April 10, 2003
LIC-03-0052

SUBJECT: Response to Request for Additional Information, Pressure-Temperature Limits Report Amendment Request

**Response to NRC Request for Additional Information
Pressure-Temperature Limits Report (PTLR)**

REVISED
TECHNICAL DATA BOOK
RCS PRESSURE AND TEMPERATURE LIMITS REPORT

Figure 5-1

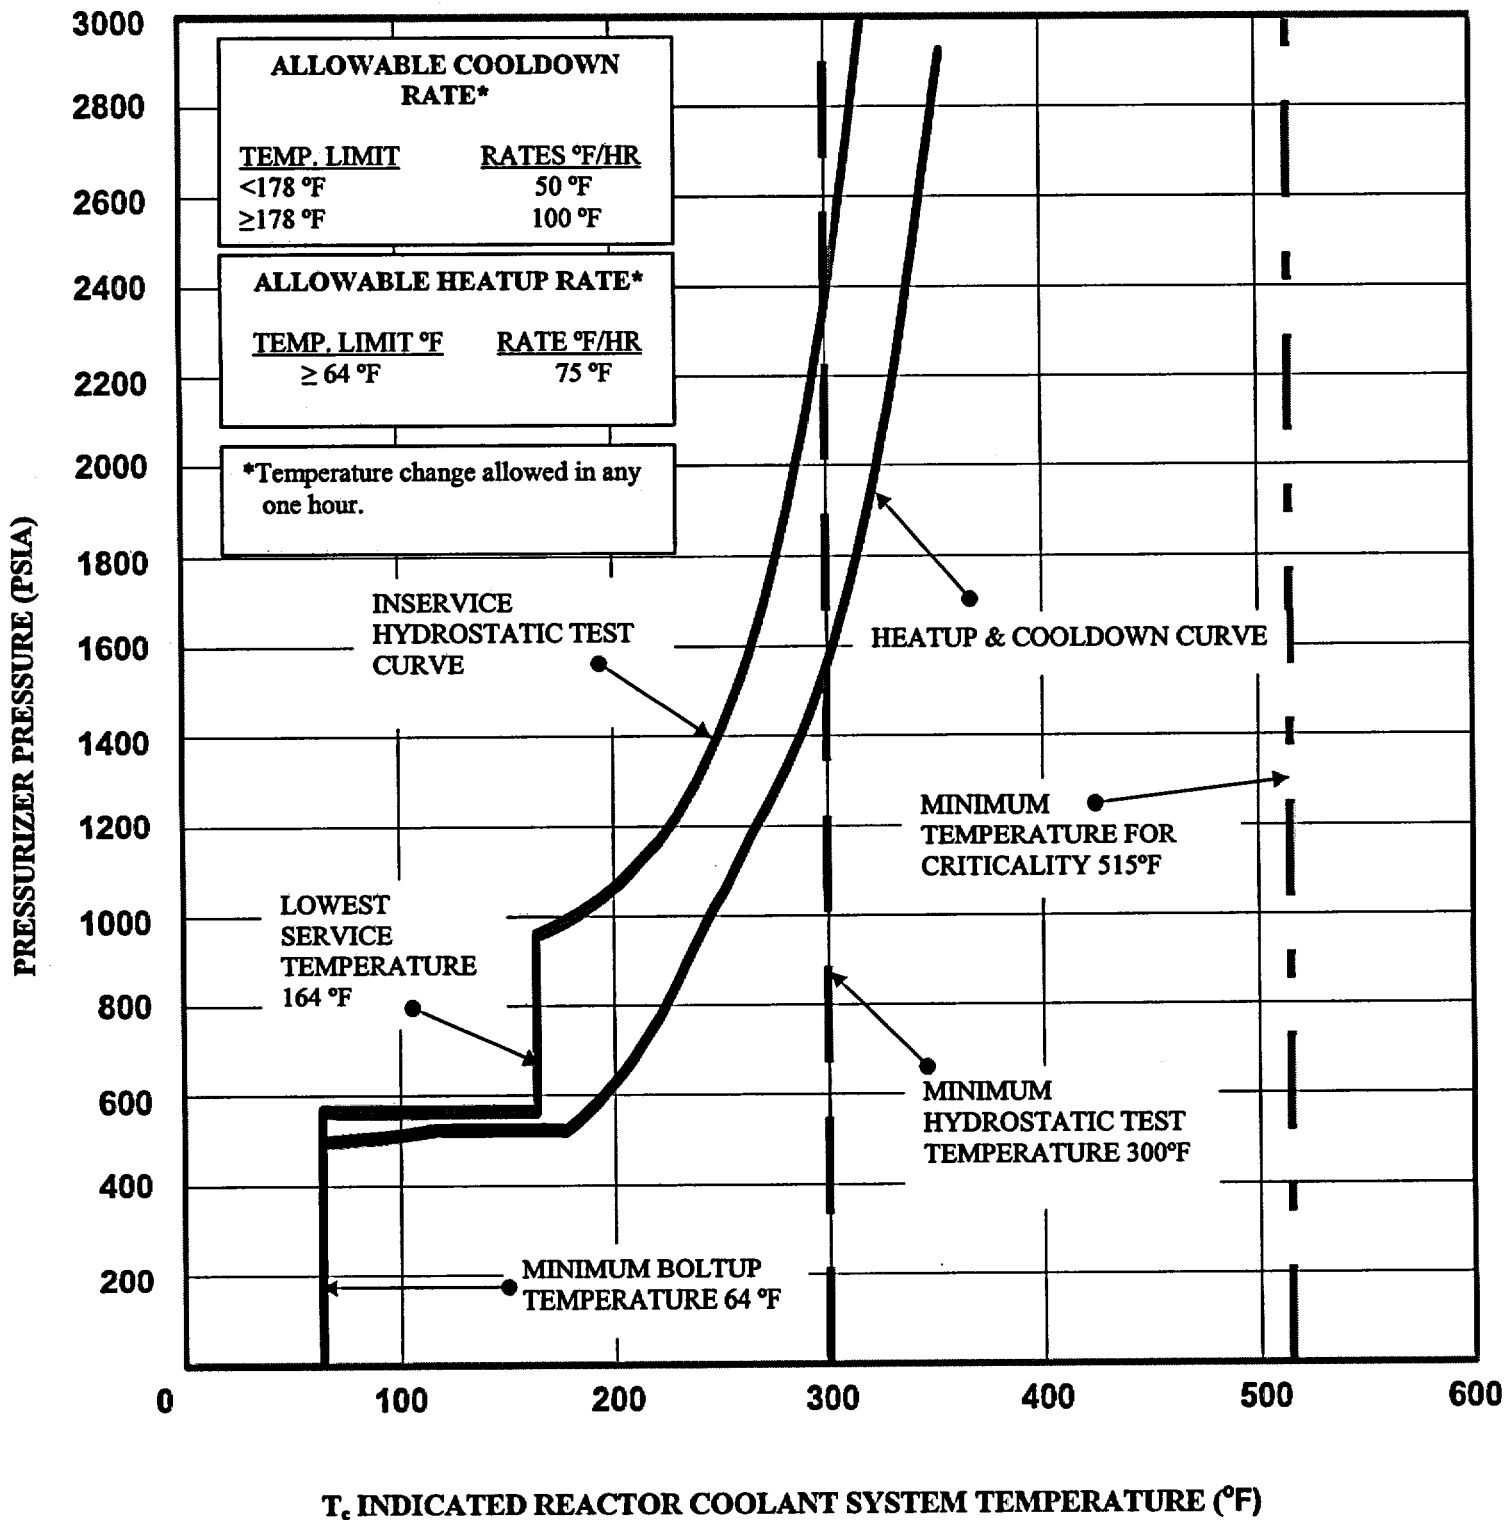
The application states that the current "criticality limit" for Ft. Calhoun is 300 °F, and that such a limit is used in lieu of a core critical operation P-T limit curve. However, it appears that an imposed criticality limit of 300 °F may not be adequate to bound the 10 CFR Part 50, Appendix G core critical operation P-T limit curve all the way up to normal operating pressure. Explain how a core criticality limit of 300 °F is adequate to bound operation up to normal operating pressure, or propose a modified limit which would bound the core critical operation P-T limit curve. Further, whatever the criticality limit is, it should be noted on P-T limit figure in PTLR consistent with other minimum temperature requirements (see GL 96-03 Table Items 5 and 6.)

Consistent with GL 96-03 Table Items 5 and 6, the minimum hydrotest temperature should be identified on the P-T limit curve in the PTLR.

Technical specification 2.10.1(1) requires that the reactor can not be made critical unless reactor coolant system temperature is greater than 515 °F which is more conservative than the core critical temperature limit required by 10 CFR 50 Appendix G. OPPD will ensure that when the P-T limit curve must be modified that the new core critical peak temperature limit will be verified to be less than 515 °F, or else the core critical P-T limit curve will be included on the P-T limit curve of the PTLR. Additionally, Section 6.0, item 'e' will be updated as applicable. The criticality temperature has been added to the P-T limit Figure in the revised PTLR (Attachment 2).

The minimum hydrotest temperature has been identified on the P-T limit curve in the revised PTLR (Attachment 2).
